Attachment #2

Foundation

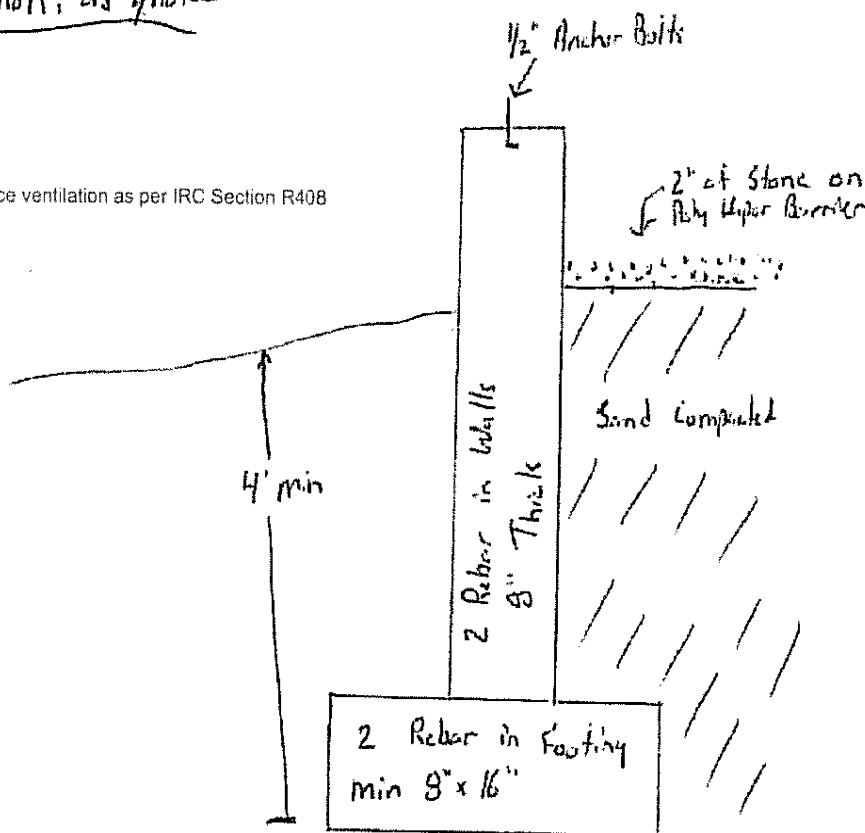
No insulation, as quoted

Show under floor space ventilation as per IRC Section R408

2x3 Vent

Vented
 into
 Existing
 Foundation
